Groundwater Transfer Review Summary Form

Transfer/PA # T- 14449

Application: T-14449

Applicant Name: City of Banks

Cross-section 1: N-S, proposed APOA “AN Well” and “AS Well” and WASH 77444, WASH 50693**Cross-section 2: W-E, proposed APOA “AN Well” and WASH 79189, WASH 56924**

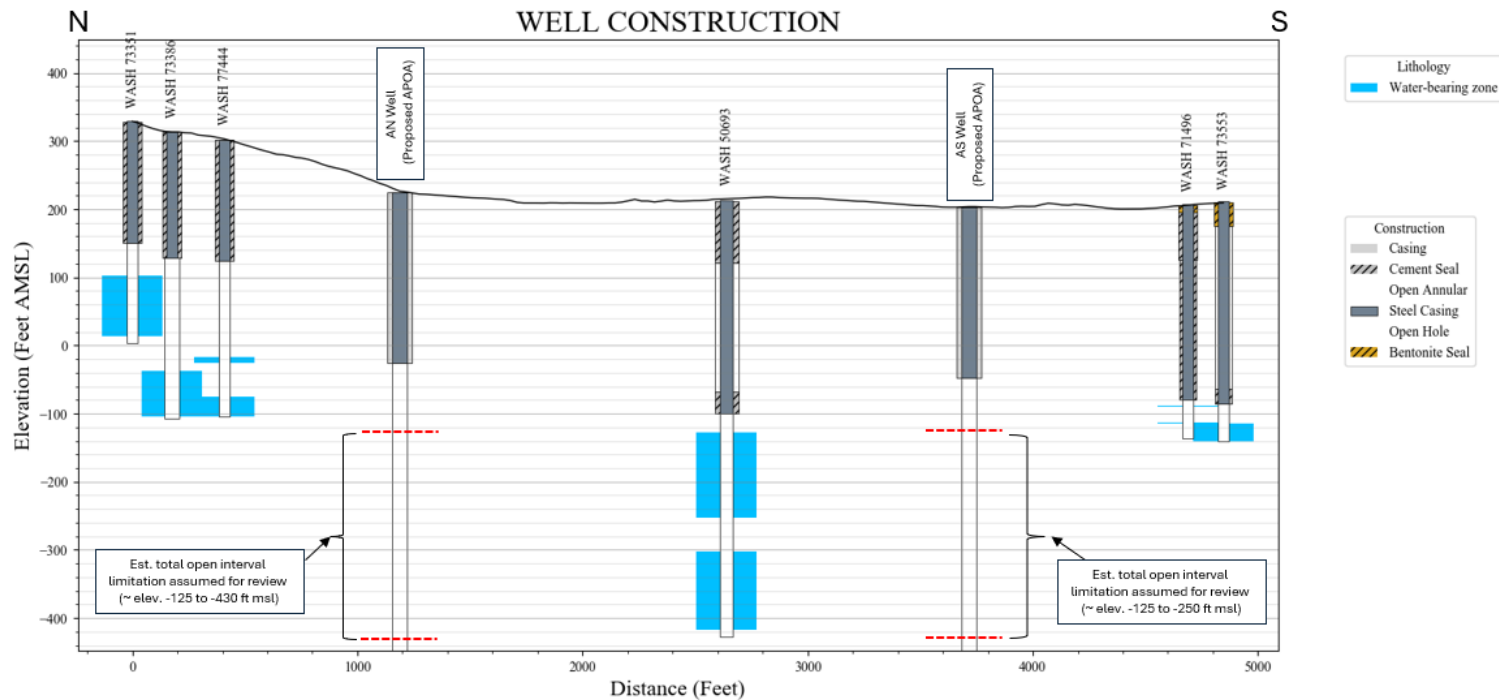
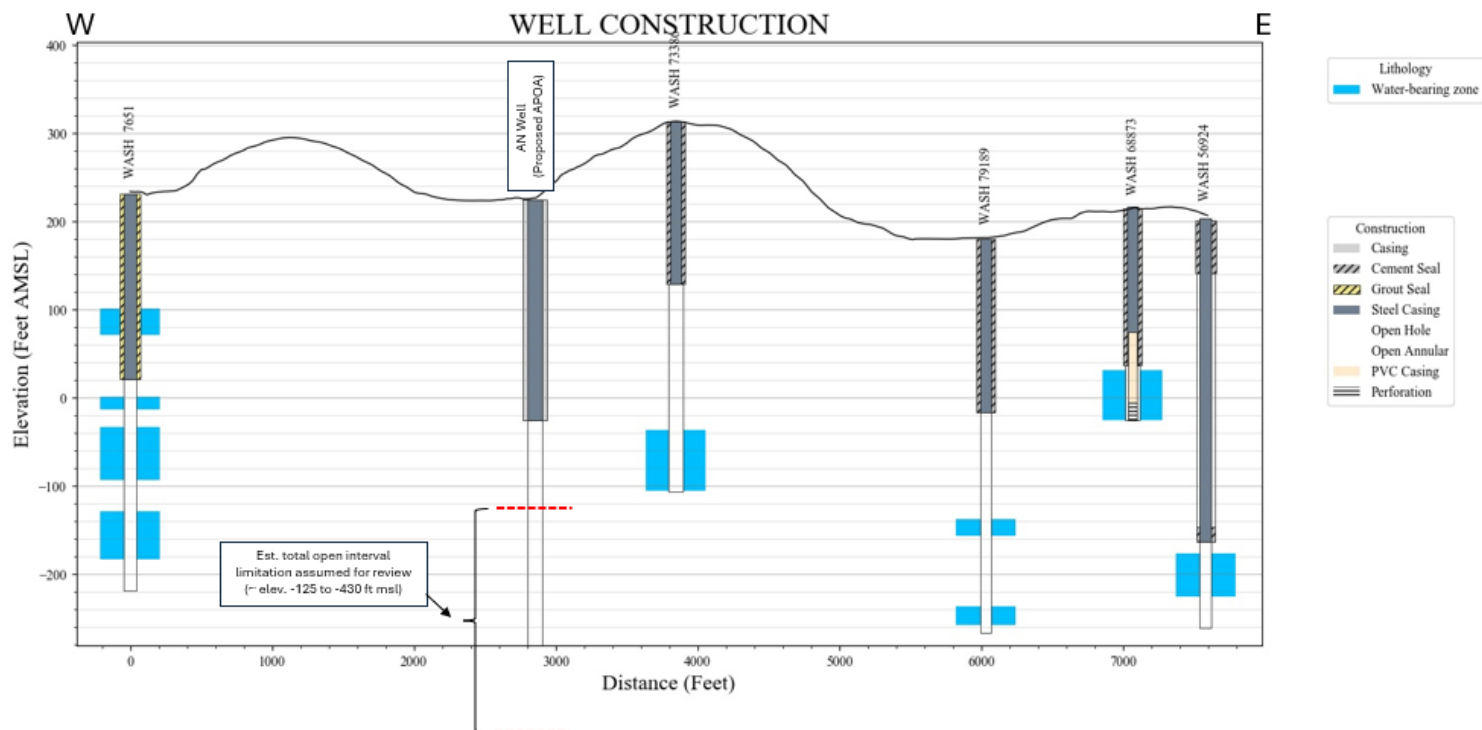
The key WBZ in WASH 77444 (between elev. ~-20 to -105 ft msl) is above the assessed WBZ in the “AN Well” (between elev. ~-125 to -430 ft msl); nearby WASH 73386 is similarly completed (see attached **cross-section 1**). Because WASH 77444 and WASH 73386 are located at a higher ground surface elevation than the “AN Well” location, it is possible that the WBZ at those two wells is approximately the same as the uppermost WBZ (elev. -125 - -250 ft msl), but has potentially been vertically offset by faulting between the two locations (the fact that existing geologic maps do not show a fault at this location does not preclude the possible existence of one). Faults typically truncate basalt interflow zones/WBZ, which would reduce or eliminate hydraulic connection between wells on either side of the fault. Whether or not a fault is present at this location, it is likely that there is **not** an efficient hydraulic connection (or any whatsoever) between the “AN Well” and WASH 77444, WASH 73386, or other nearby wells of similar completion, and thus those wells are unlikely to be injured due to the proposed use of the “AN Well.”

Farther to the east, the completion depths and open intervals of other wells (namely WASH 79189 and WASH 56924) partially overlap the approved completion interval, and are thus more likely to be adversely affected by pumping at the “AN Well” location (see attached **cross-section 2**).

Pumping of the “AN Well” could also affect WASH 50693, the Quail Valley Golf Course well which is an authorized POA for a supplemental irrigation water right (certificate 91527). Relative to authorized POA WASH 7651, the “AN Well” location is about 1750 feet nearer to WASH 50693 (see **cross-section 1**). However, during the 2009 aquifer test of WASH 62373, which is located about 60 feet from WASH 7651 and is constructed more like WASH 50693 (both access a key deeper WBZ that is not present in the shallower WASH 7651), only about 2 feet of additional drawdown was measured in WASH 50693 (Golder Associates, 2009). Therefore, it is unlikely that pumping of the “AN Well” would negatively affect the current usage of WASH 50693.

Theis Drawdown Analysis, Authorized POA WASH 7651 to WASH 79189**Theis Time-Drawdown Worksheet** v.5.00

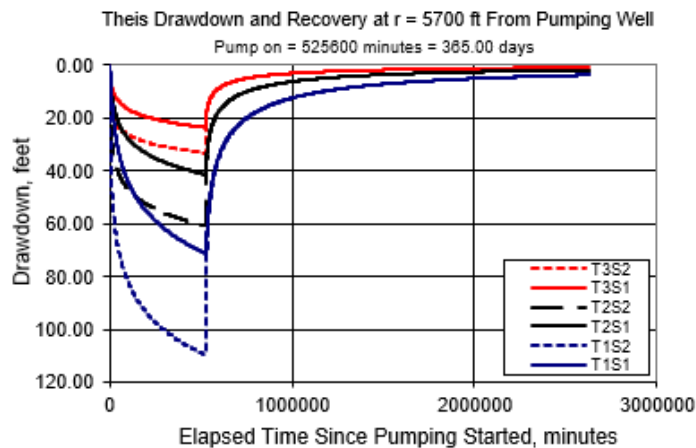
Relative to the location of authorized POA WASH 7651, the proposed location for the “AN Well” is about 2700 feet nearer to WASH 79189. The results of the Theis interference analysis indicates that additional interference in WASH 79189 could potentially range from about 10 to 20 feet due to pumping the maximum rate (0.67 cfs) 24/7/365 from the “AN Well” (see attached Theis analysis results).

**Theis Drawdown Analysis, Proposed APOA "AN Well" to WASH 79189****Theis Time-Drawdown Worksheet** v.5.00

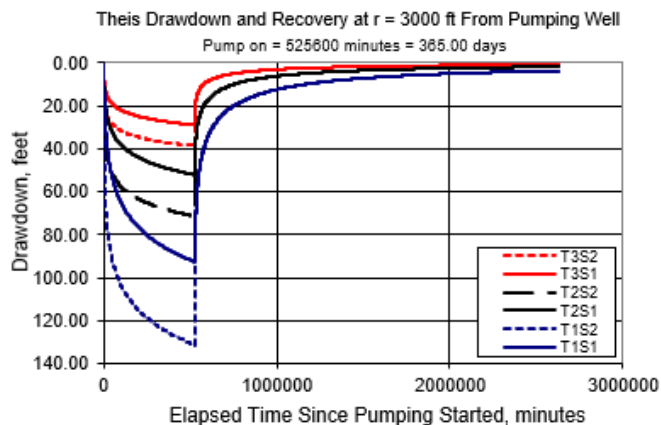
Limited water level data from other nearby wells (WASH 56924) indicates that the static water level in WASH 79189 likely ranges from about elevation 180 to 200 ft msl, which would provide roughly 200 feet or more of available drawdown in both it and existing wells of similar completion. This approximate range of available drawdown should be sufficient to support ongoing usage of these wells with the change proposed by this application (i.e., the change will not prevent those wells from receiving the groundwater to which they are legally entitled).

Cross-section 3: N-S, proposed APOA “AS Well” and WASH 50693, others

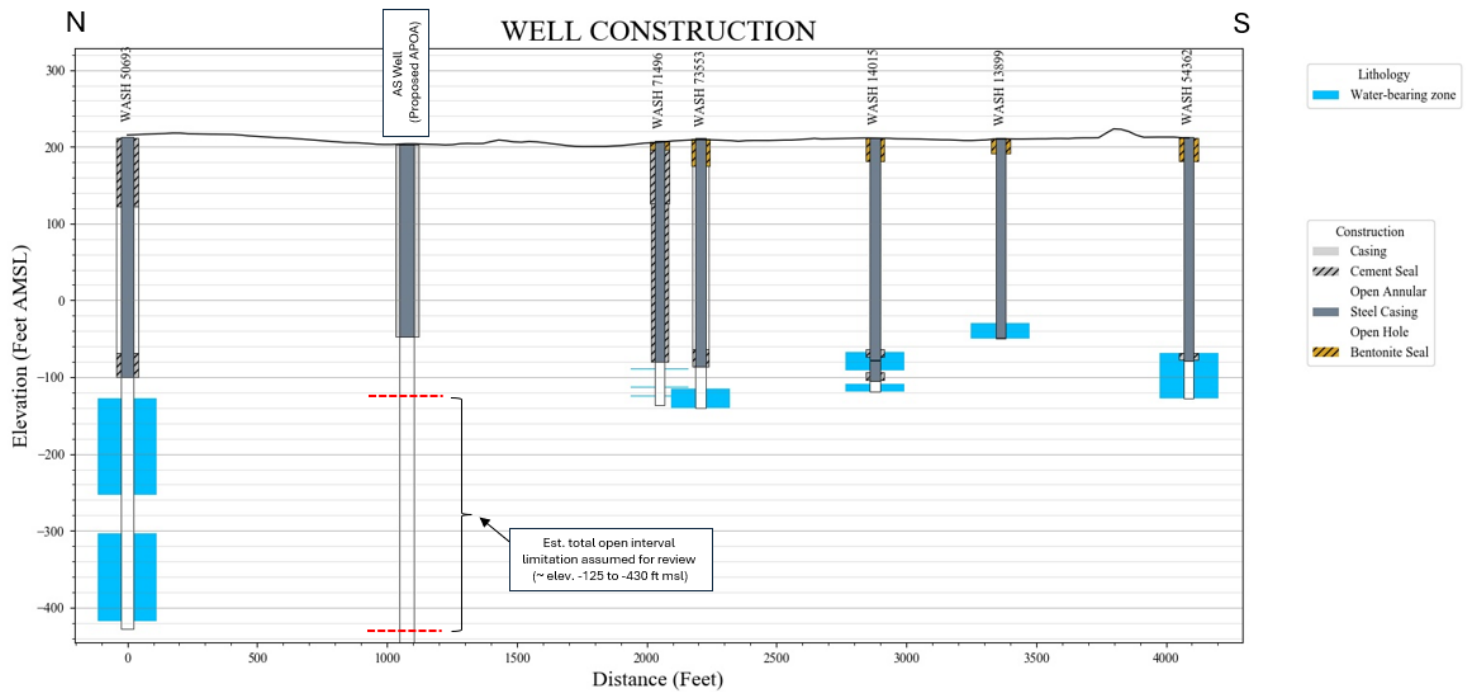
Relative to the location of authorized POA WASH 7651, the proposed location for APOA “AS Well” is about 3600-3800 feet nearer to WASH 71496, WASH 73553 and several other domestic wells in the area. However, all of these existing wells are relatively shallow with the borehole bottoms very near, or just above, the recommended casing/seal depth elevation for all of the proposed APOA (at about -125 ft msl) (see attached **cross-section 3**). It is also notable that some of these same nearby wells only access the uppermost portions of the CRBG in this area, i.e., likely the flow top at the contact between alluvial sediments and the underlying basalt, and do not extend deeper into the same or another WBZ (such wells are considered by OWRD to be “alluvial aquifer” wells and not “CRBG aquifer” wells). Because these existing wells do not fully penetrate the upper WBZ present between approximately elevation -125 to -430 ft msl, or are considered to be “alluvial wells” despite partial penetration into the upper basalt unit, an injury determination would not be made due to the proposed use of the “AS Well.”

Relative to the location of authorized POA WASH 7651, the proposed location for APOA “AS Well” is also much nearer to WASH 50693, the QVGC well. However, as discussed previously for the “AN Well”, it is also unlikely that the proposed use of the “AS Well” will prevent WASH 50693 from receiving the groundwater to which it is legally entitled, for the same stated reasons.

Cross-section 4: N-S, proposed APOA “Park-A Well” and WASH 52798

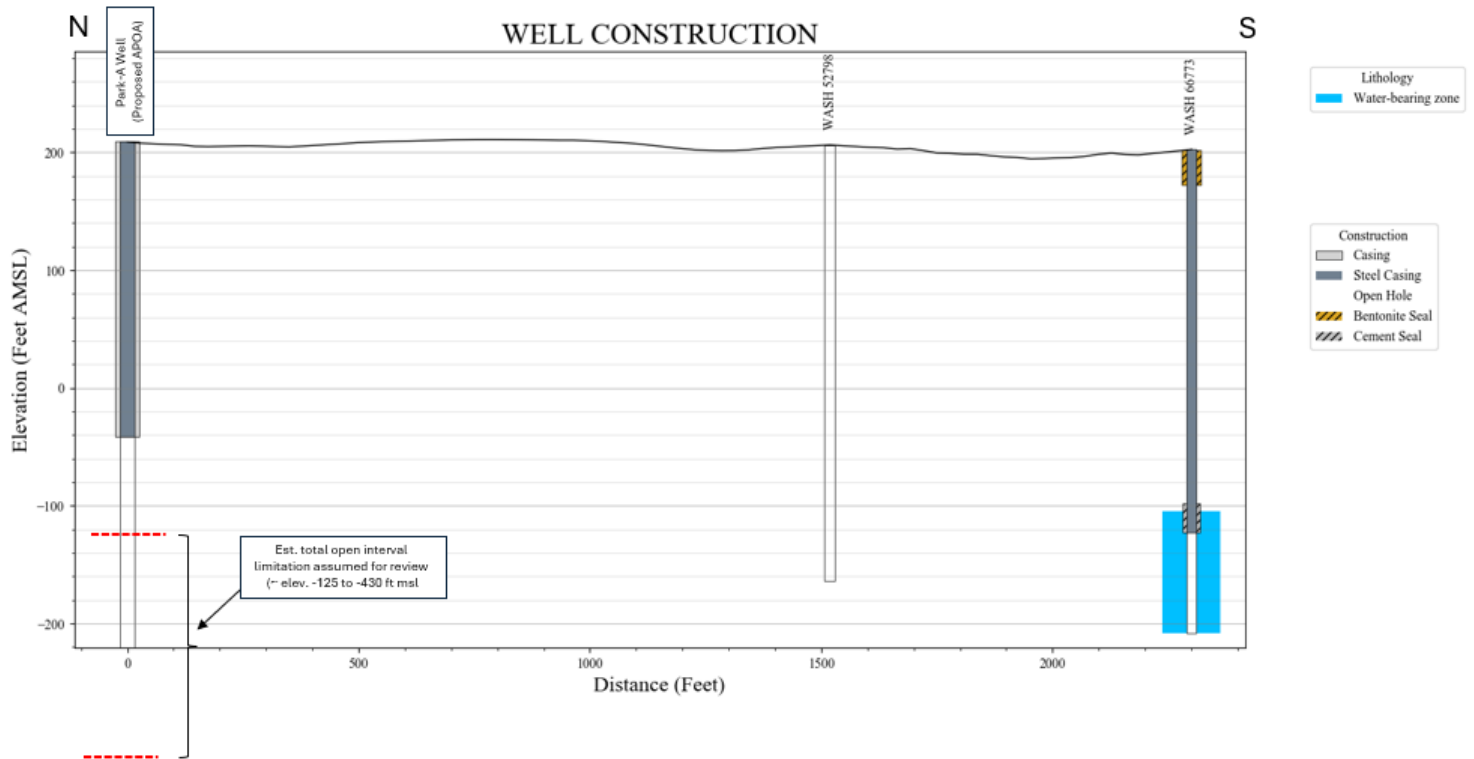
Of the three “Park” wells proposed as APOA, the location for the “Park-A Well” is nearest to the known locations of existing wells. Relative to authorized POA WASH 7651, the “Park-A Well” location is approximately 3000 feet nearer to WASH 52798, an exempt domestic use well. WASH 52798 is reportedly 370 feet deep, but the log does not provide any other information related to well construction or local lithology (see attached **cross-section 4**).

However, nearby WASH 66773 is a comparable depth (410 feet deep), and like all other nearby wells of similar depth, obtains groundwater from the CRBG aquifer system. The WASH 66773 log shows a 2008 static water level elevation of 167 ft msl (depth 35 ft bgs); a similar current static water level assumed for WASH 52798 and other nearby wells indicates that these wells likely have about 200-300 feet of available drawdown. This approximate range of available drawdown should be sufficient to support ongoing usage of these wells with the change proposed by this application (i.e., pumping of the “Park-A Well” will not prevent those wells from receiving the groundwater to which they are legally entitled).

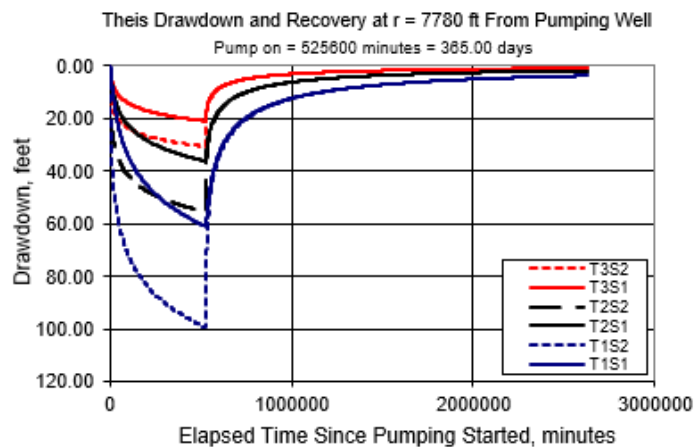
The results of the Theis interference analysis indicates that WASH 8102/8089 could potentially experience about 30 to 90 feet of additional drawdown due to pumping the stacked maximum rate (1.67 cfs) 24/7/365 from WASH 62373 (see attached Theis analysis results). While this range of additional drawdown is relatively large compared to other evaluations, from available static water-level data it is likely that WASH 8102/8909 has approximately 350 to 380 feet of available drawdown. Thus it is unlikely that this additional drawdown estimated for WASH 8102/8089 would prevent it or other similarly-constructed wells in the area from receiving the groundwater to which they are legally entitled.

Theis Drawdown Analysis, Proposed APOA “WTP Well” to WASH 8102/8909

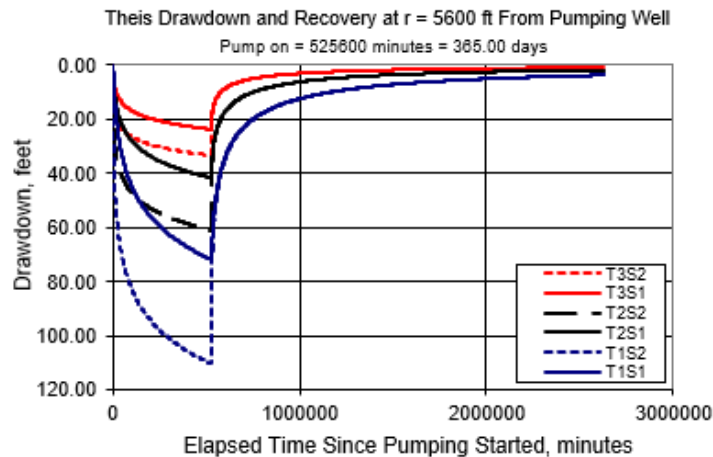
The results of the Theis interference analysis indicates that WASH 8102/8089 could potentially experience about 5 to 10 feet of additional drawdown due to pumping the maximum rate (0.67 cfs) 24/7/365 from the “WTP Well” (see attached Theis analysis results). It is unlikely that this small additional drawdown estimated for WASH 8102/8089 would prevent it or other similarly-constructed wells in the area from receiving the groundwater to which they are legally entitled.
